ADDENDUM 1

Douglas Road Improvements and Signalization Project
Federal Aid No. STPR-8030 (003)

ADDENDUM NO. 1

**Douglas Road Improvements and Signalization Project
Federal Aid No. STPR-8030 (003)**

JOB# / DWG	DATE
00008 00008.SP2	7-20-07
SCALE	SHEET
H:1"=20' V:1"=2'	8 of 17

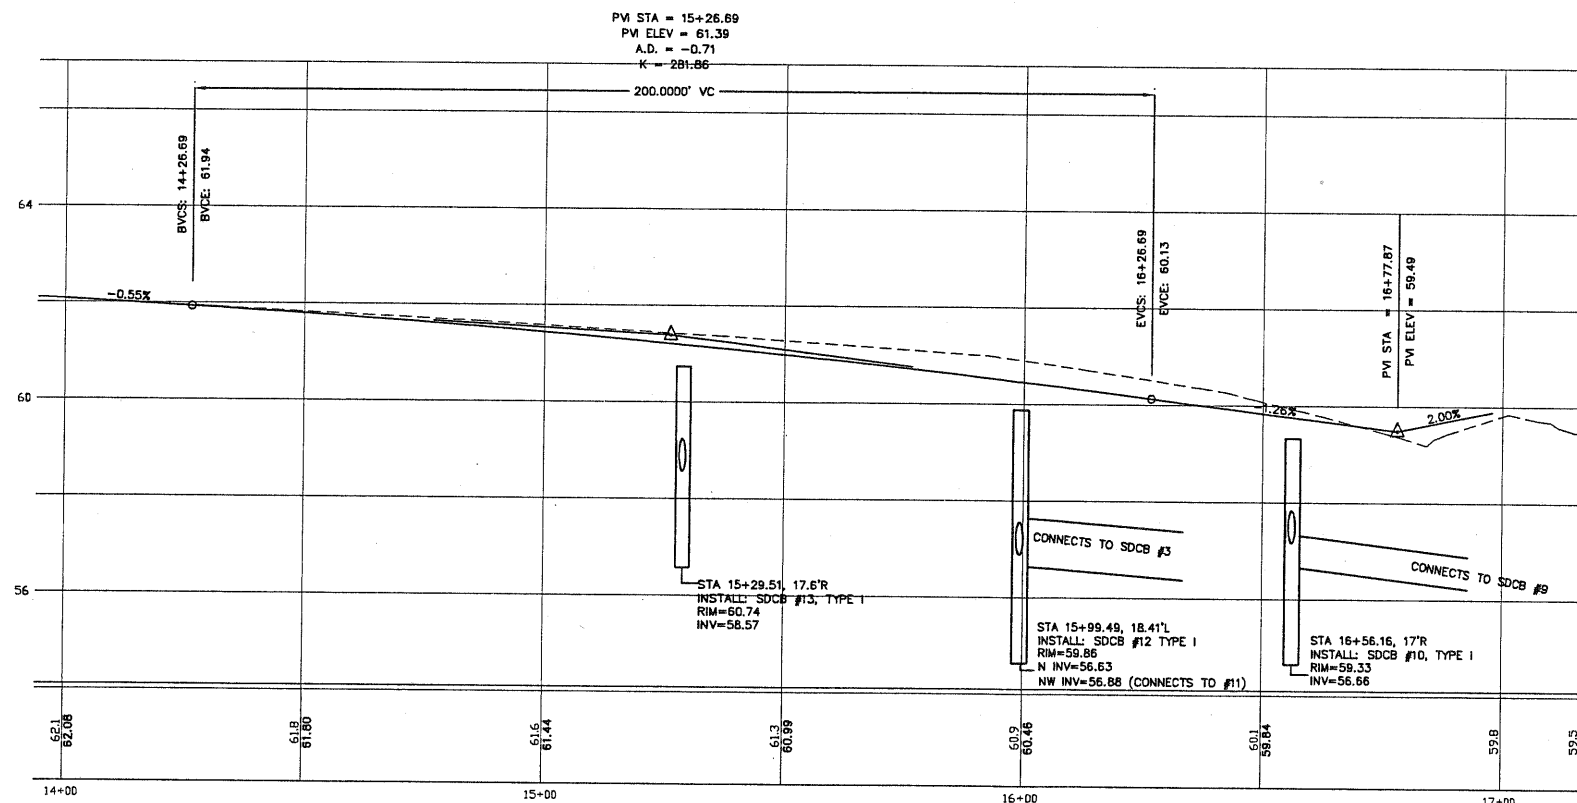
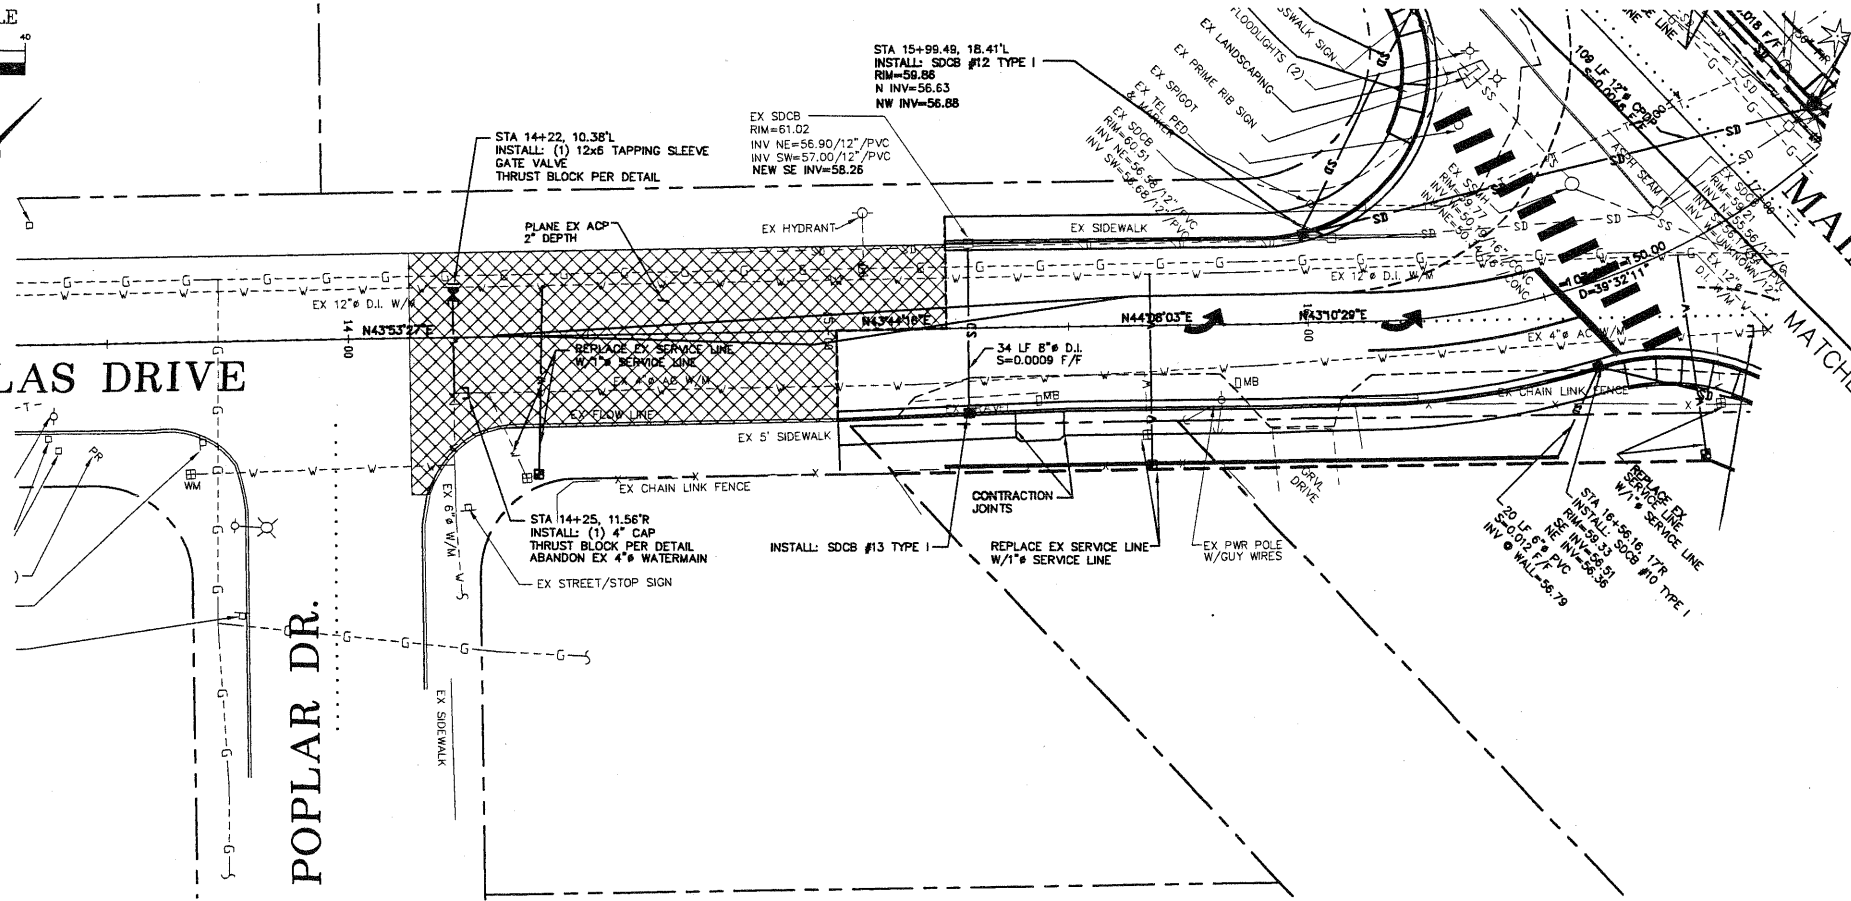
The attached Plan Sheet 8 dated Rev 8-10-07 shall replace the Plan Sheet 8 dated 7-20-07. The planing limits have been extended further south along Douglas Road. The planing limits shown on Plan Sheet 8 dated Rev 8-10-07 shall supersede the planing limits shown on all other Plan Sheets.

JOB# / DWG	DATE
00008 00008.SP2	7-20-07
SCALE	SHEET
h:1"=20' v:1"=2'	10 of 17

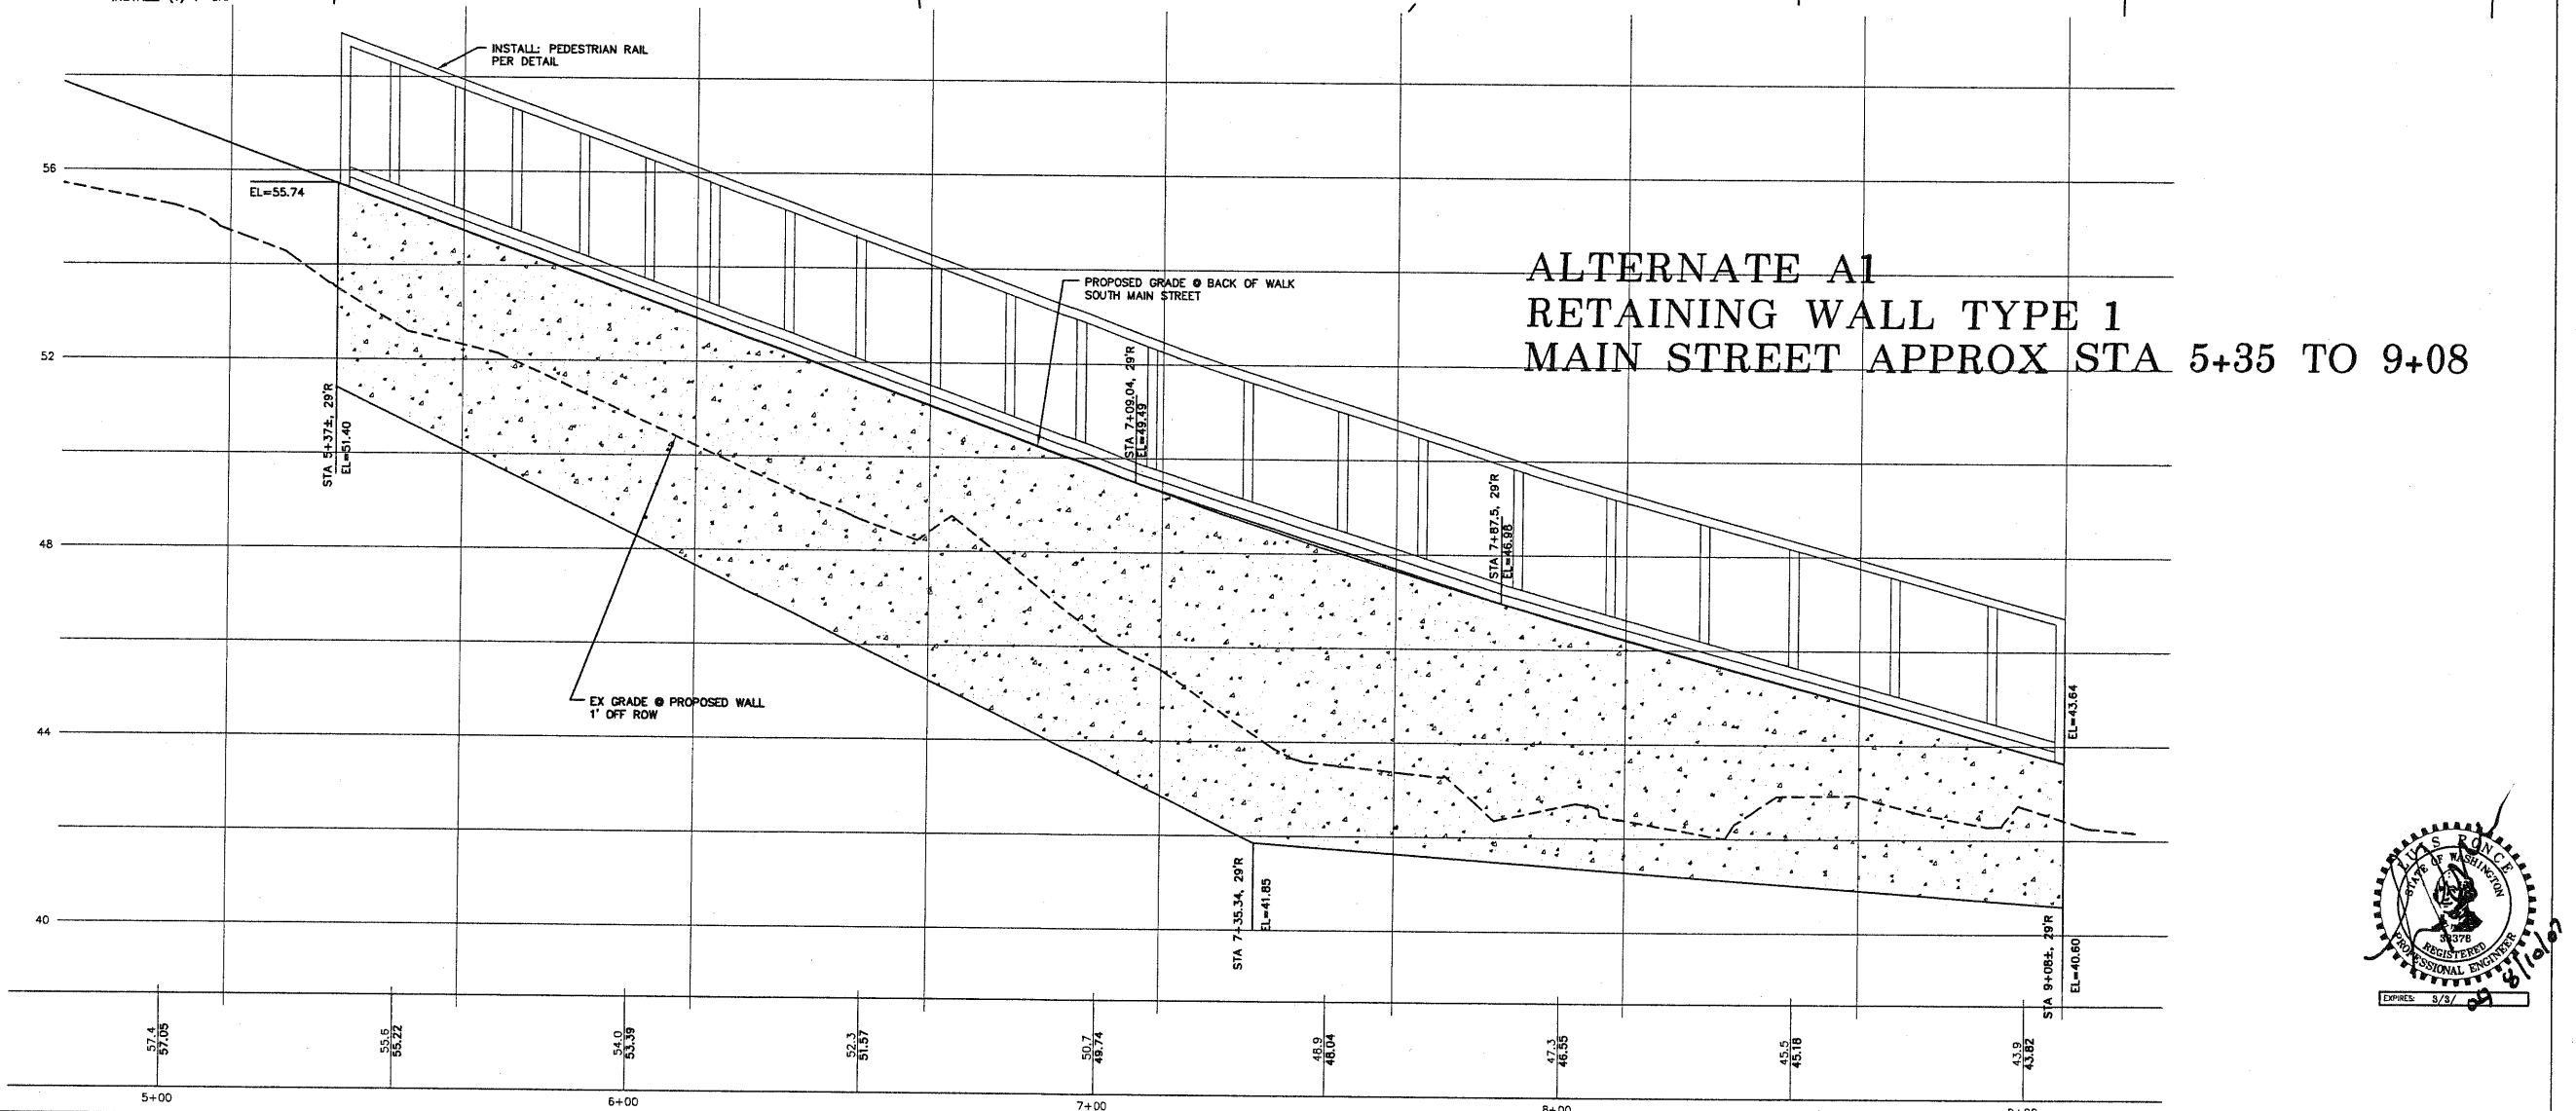
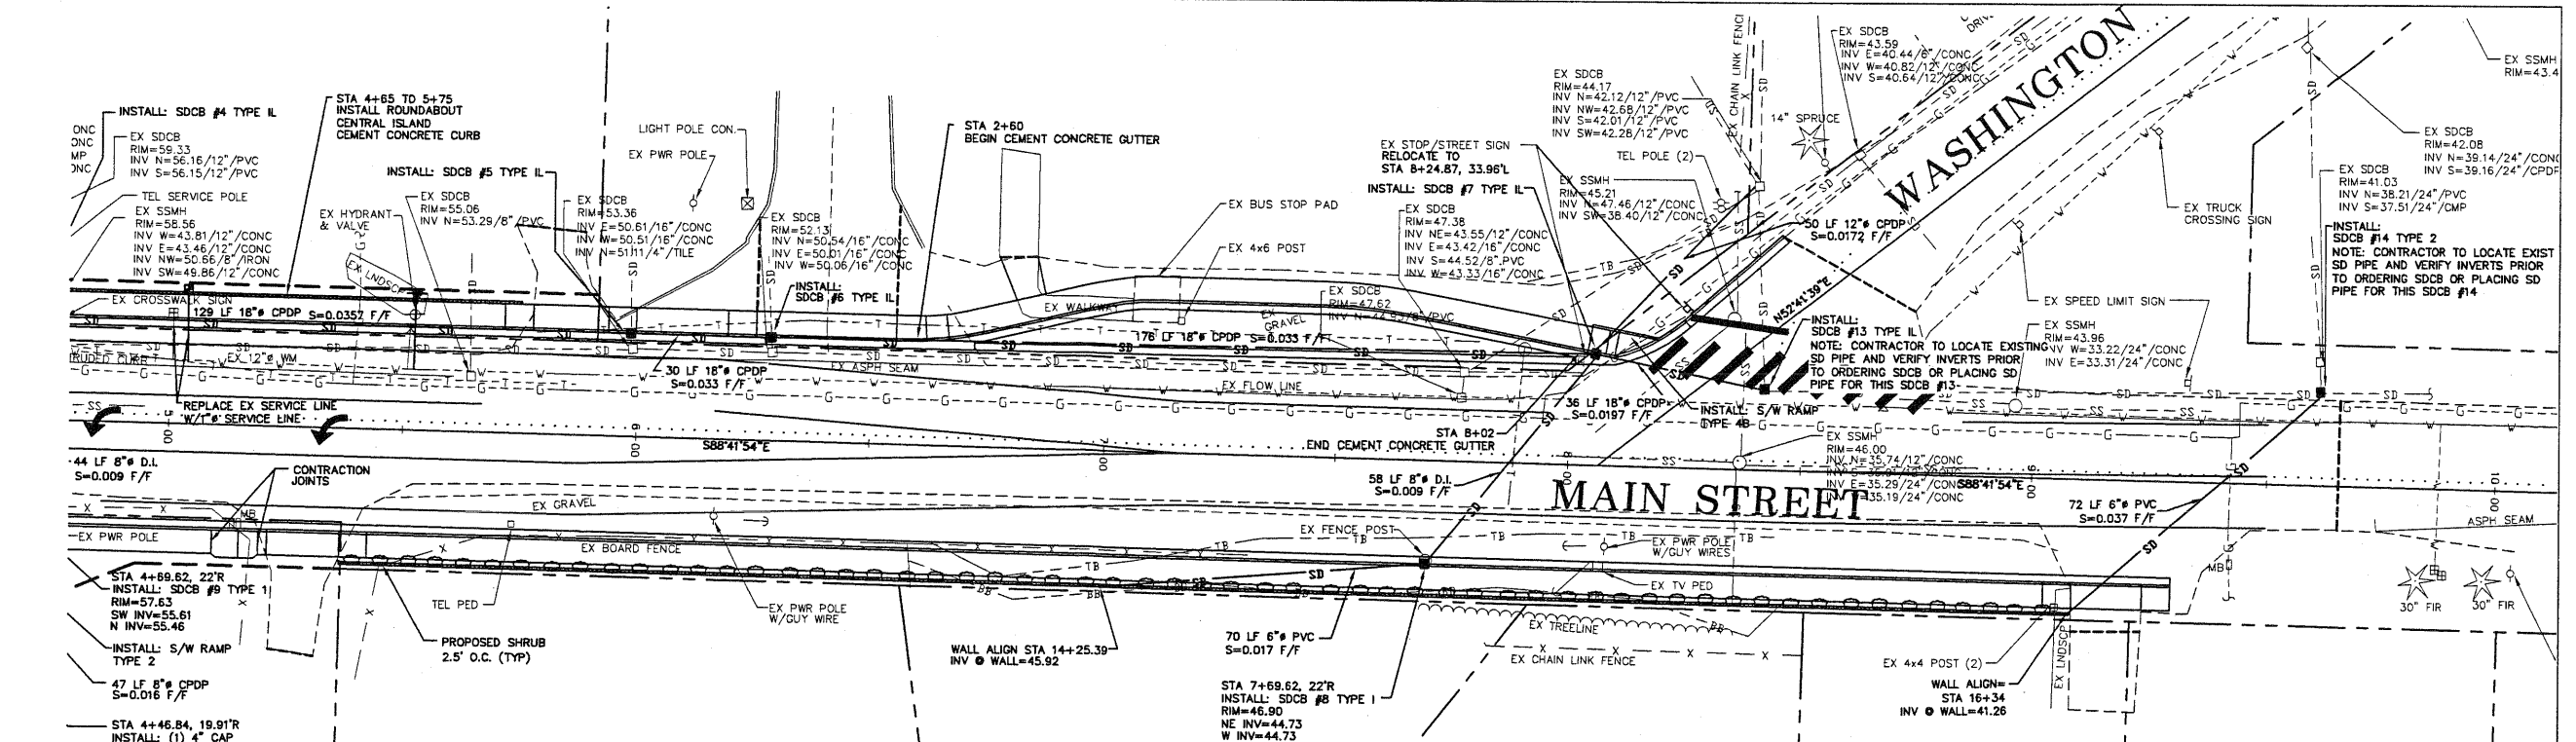
The attached Plan Sheet 10 dated Rev 8-10-07 shall replace the Plan Sheet 10 dated 7-20-07. The elevation calls outs for the Retaining Wall Type 1 were corrected and the additional line on the Retaining Wall Type 1 profile view was removed. The location of 'Plant Selection Thuja Pyramidis Occidentalis, Emerald Green Tree' is added.

JOB# / DWG	DATE
00008 00008.DET	7-20-07
SCALE	SHEET
n/a	15 of 17

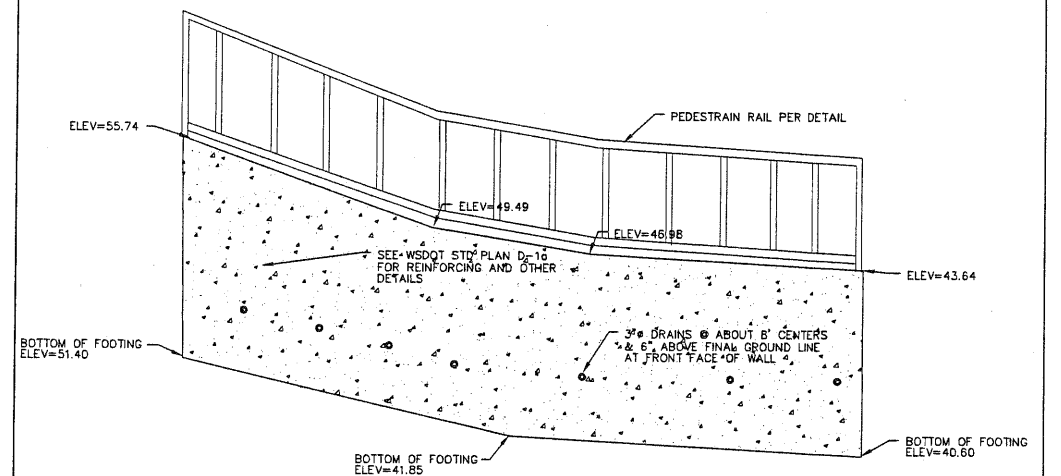
The attached Plan Sheet 15 dated Rev 8-10-07 shall replace the Plan Sheet 15 dated 7-20-07. The elevation calls outs were corrected and the additional line on the Retaining Wall Type 1 view was removed.

TS1
SHEET OF SHEETS

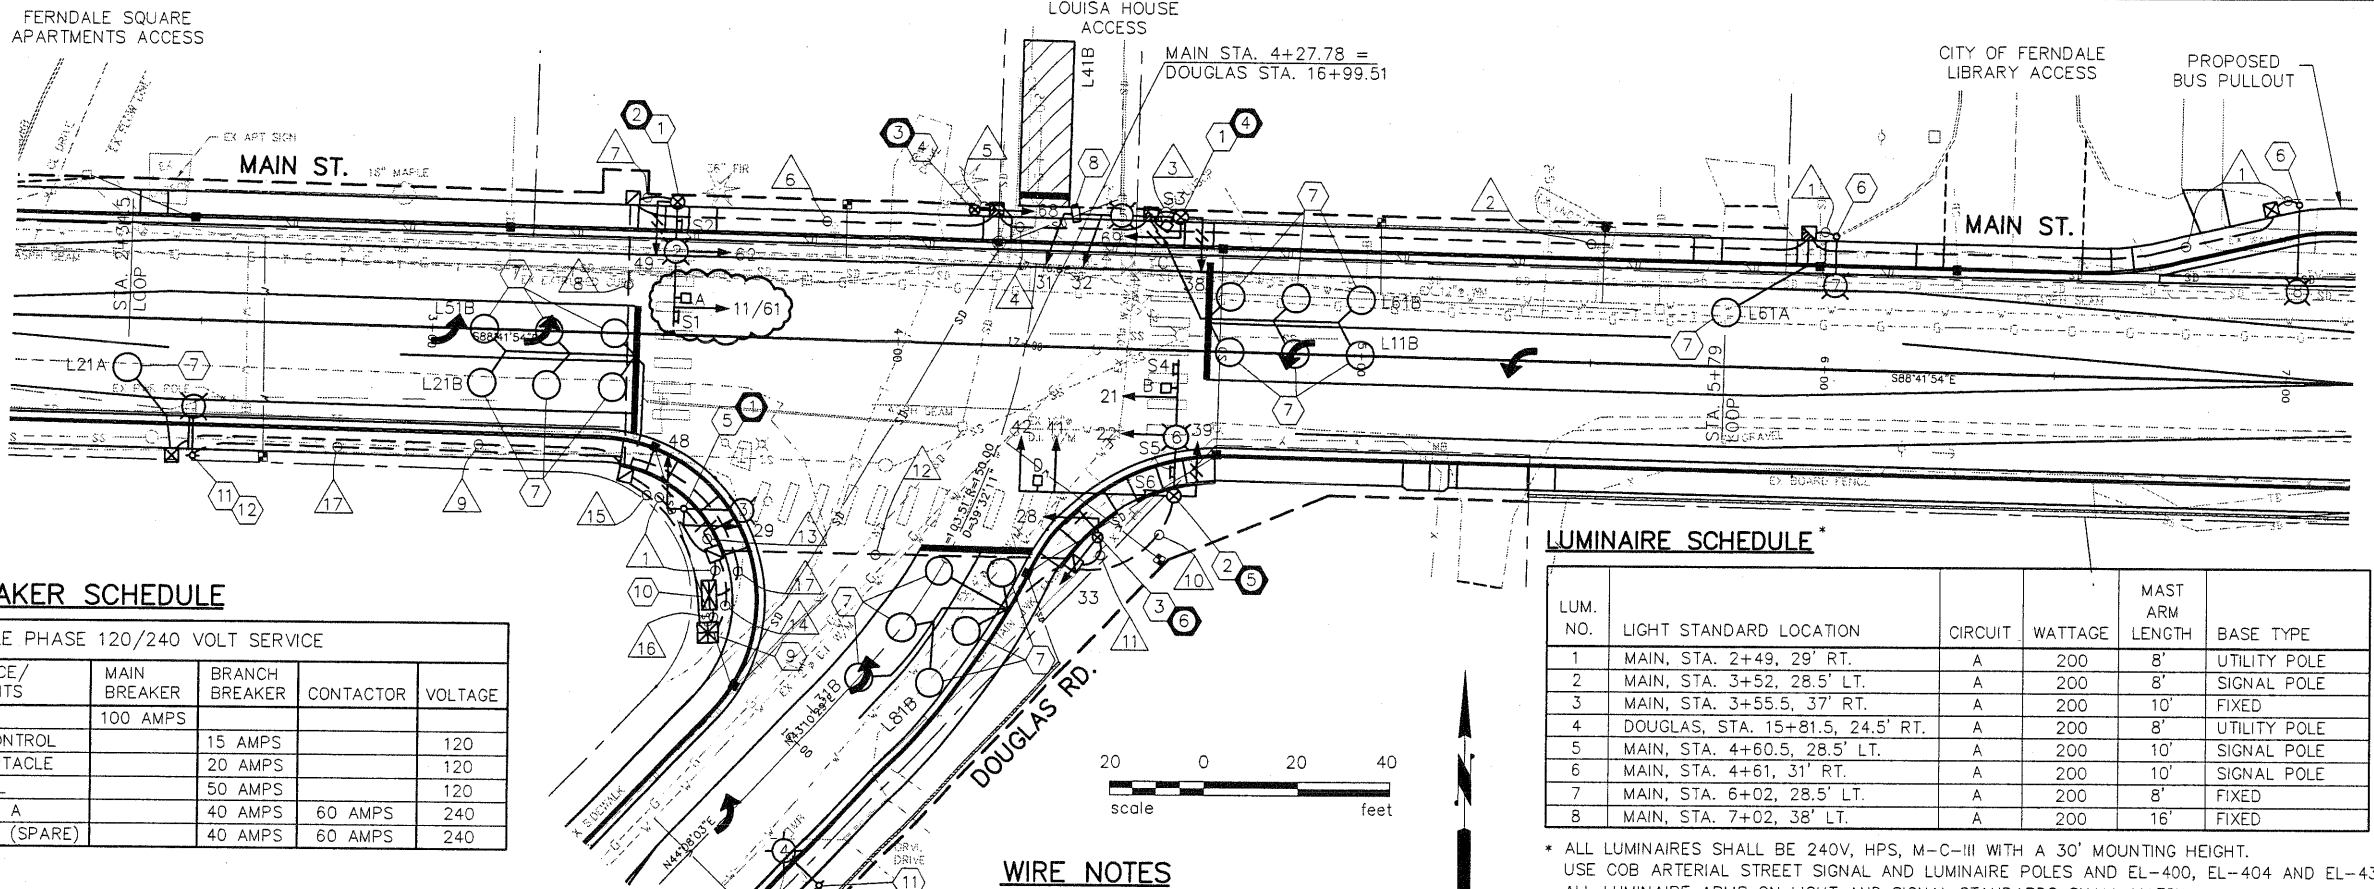
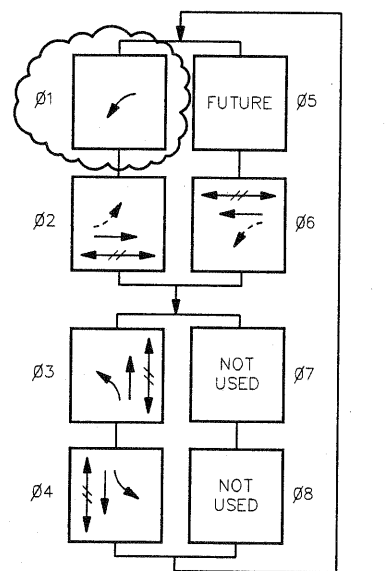
The attached Plan Sheet TS1 dated Rev. 8-10-07 shall replace the Plan Sheet TS1 dated Rev. 7-20-07. The traffic signal phasing for the westbound left turn movement has been revised from permissive only to protected/permissive phasing. A five section cluster signal head labeled 11/61 shall replace signal head 61. Vehicle detector loop L11 shall call signal phase 1 instead of signal phase 6. Emergency vehicle preemption circuit A shall call signal phases 1 and 6 instead of signal phases 2 and 6.
